MEETING NOTICE AND AGENDA

- d. Award of Bid for the construction of a 1.0MG Water Tank located above the Orchard Ridge development, and construction inspection services – Public Works.

KAYSVILLE CITY COUNCIL
February 20, 2020

SET NO.	DESIGNED	DRAWN	CHECKED	SHEET NO.
07062	MMC	IR	SH	6 of 44
				SP1

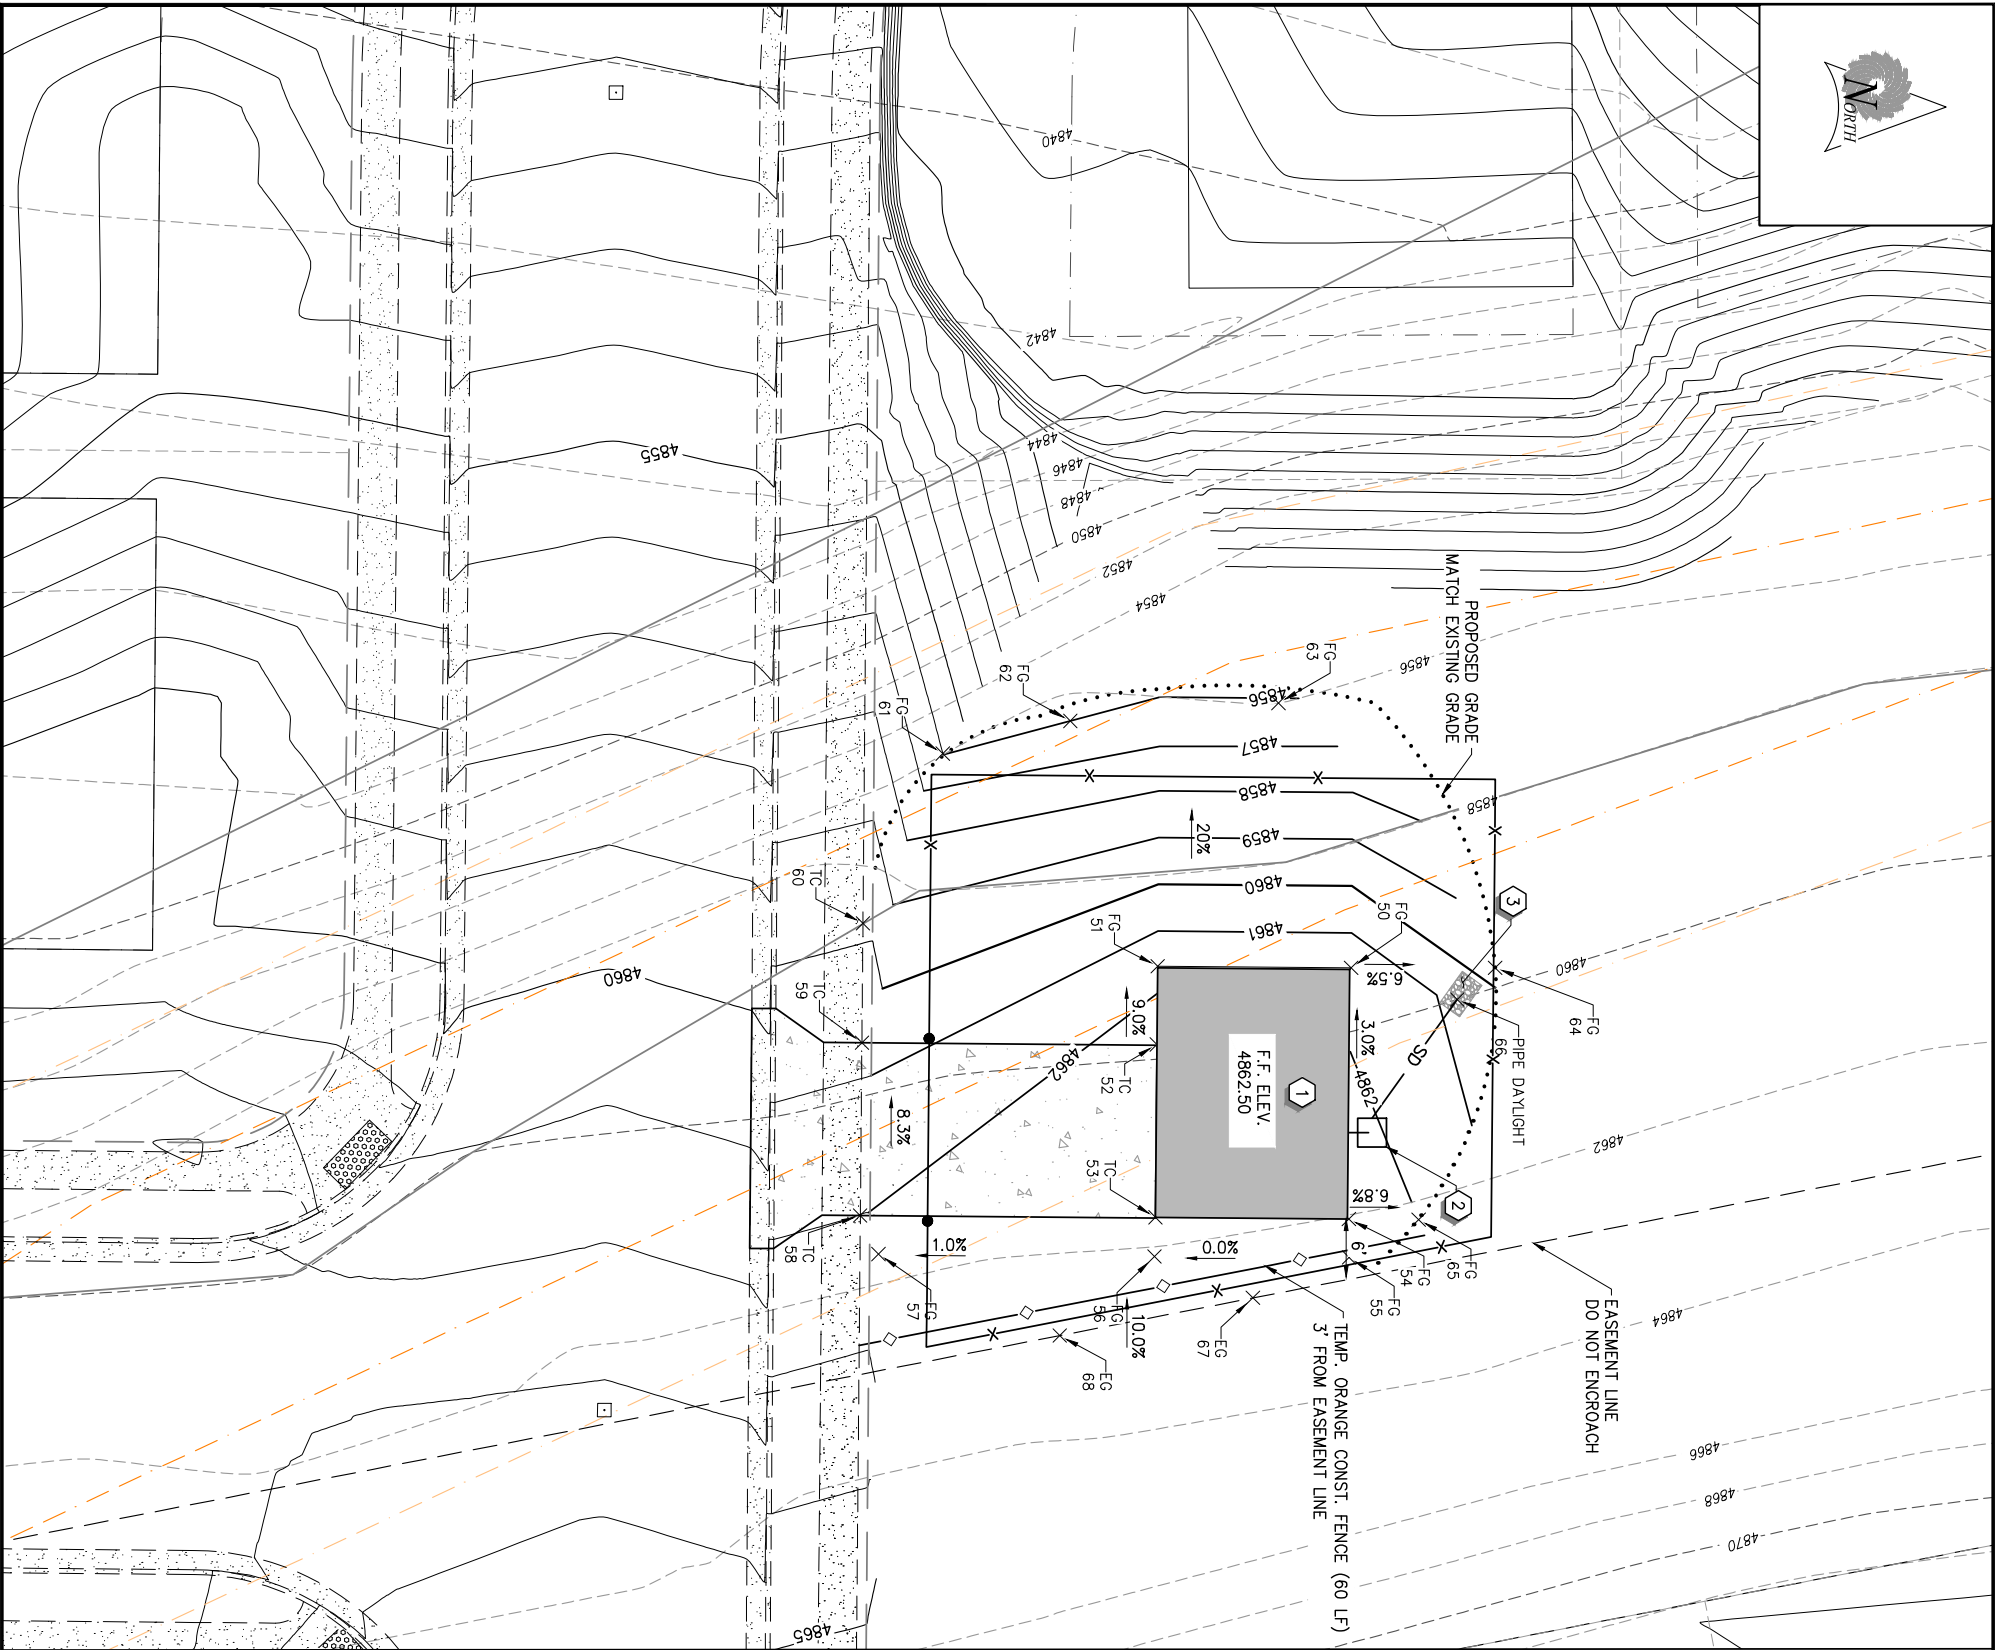
2.1 Revised Sheet SP1 of Booster Station Project

Answer: There is only one waterline currently installed. The line is an 8-inch PVC distribution line. The inlet line to the booster station will be tied to this 8-inch line using an 8x8x10 tee (See Sheet SP1). This represents the extent of inlet piping for the booster station project. The Outlet pipe will leave the booster station and, in the road, will have (2) 45-degree bends. After the second bend, the pipe shall be terminated with blind flange and thrust block per the plans. This represents the extent of outlet piping for the booster station project.

BOOSTER STATION AND TRANSMISSION LINE PLAN AND PROFILE				
SET NO.	DESIGNED	DRAWN	CHECKED	SHEET NO.
07062	SH	TR	CL	9 of 44
				PP1

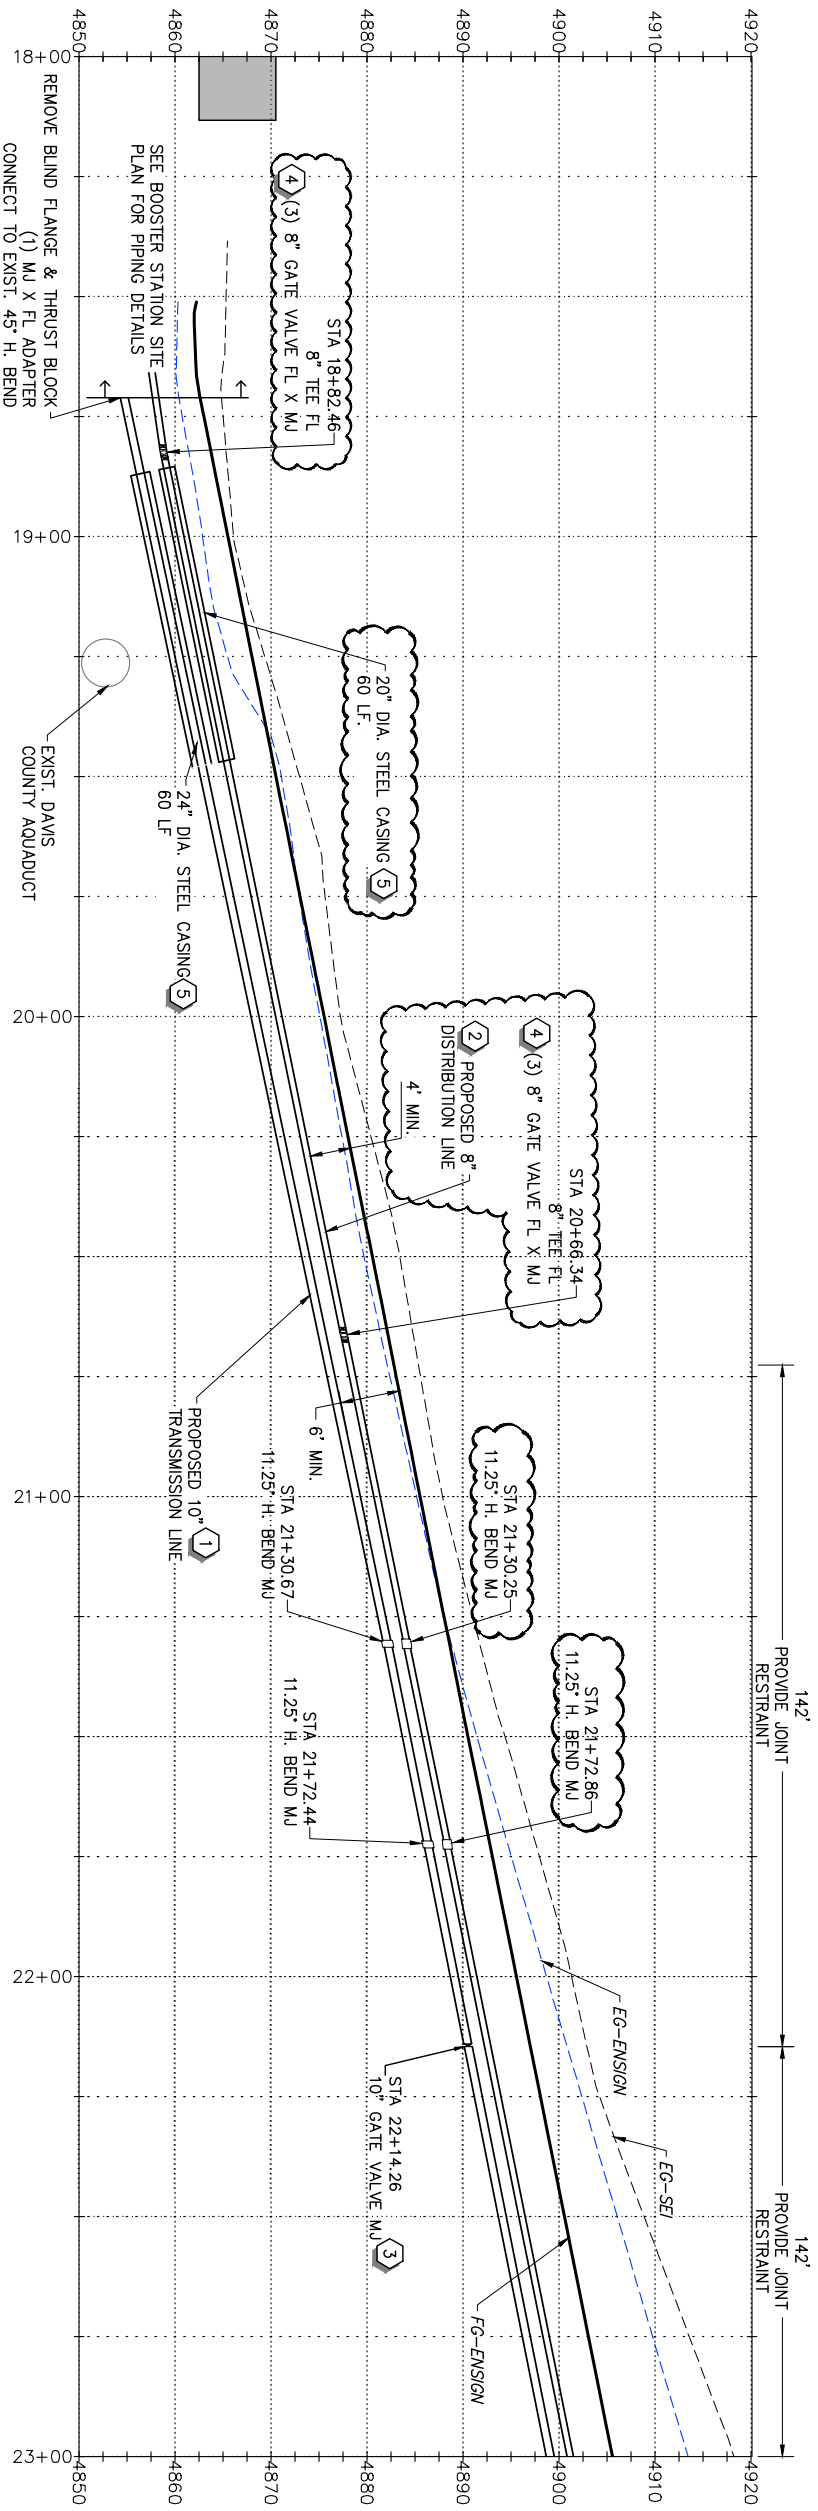
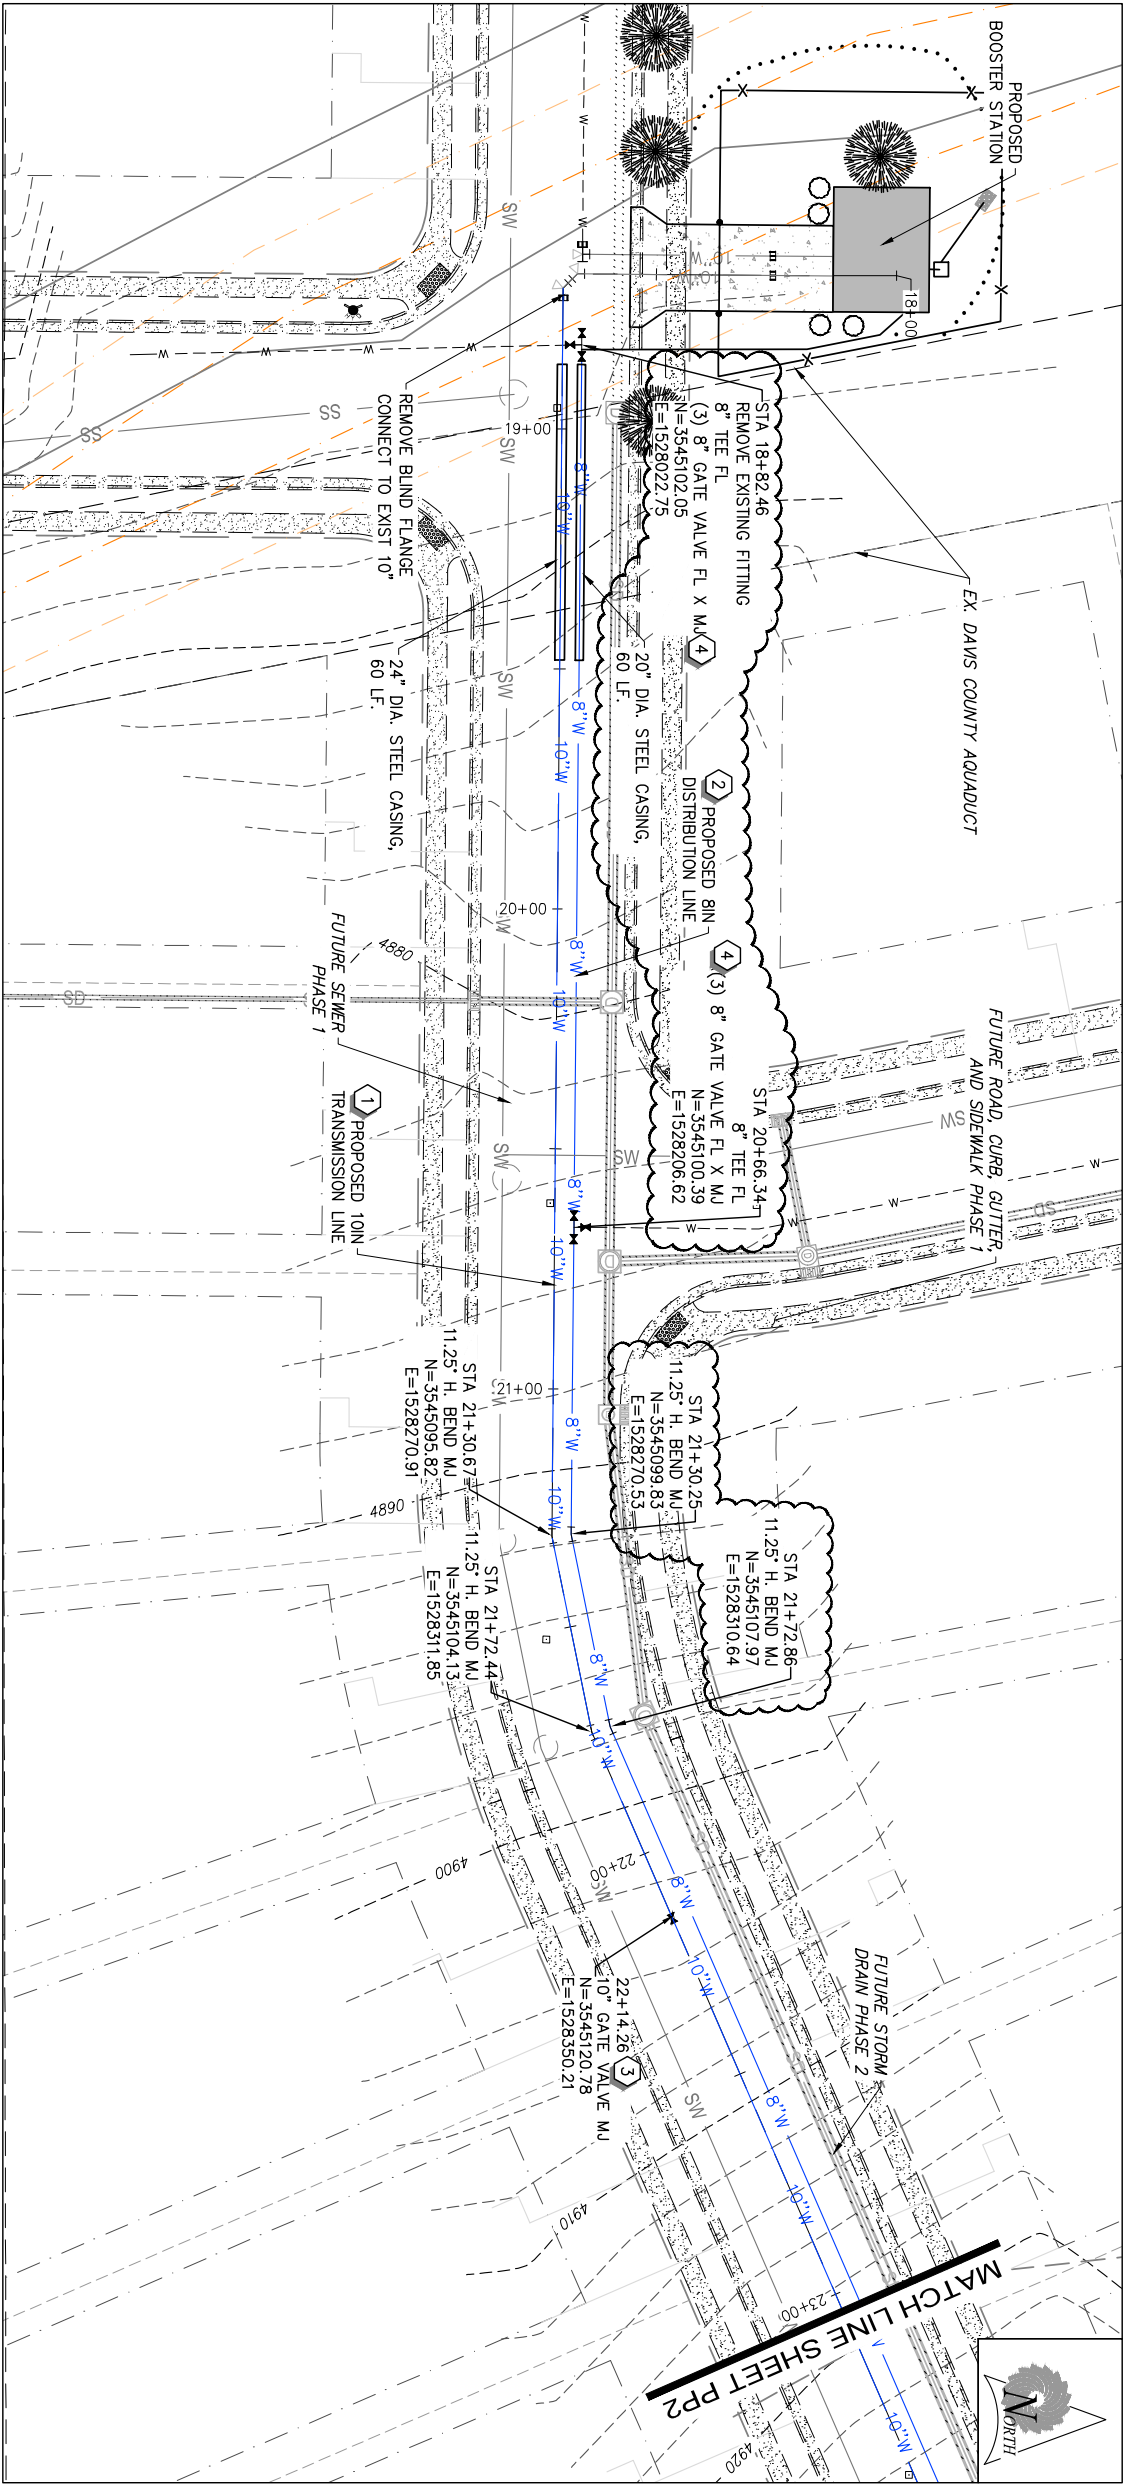
4.1 Revised Sheet PP1 of Booster Station Project

Answer: See Addendum plan sheet PP1. The casing for the 8" water line was added in the Addendum. The casing for the 10" line was in the original plan. The note for this is below the casing. A 20" diameter steel casing is required for the 8" distribution waterline. A 24" diameter steel casing is required for the 10" transmission line. Both steel casing will be 60 feet long.
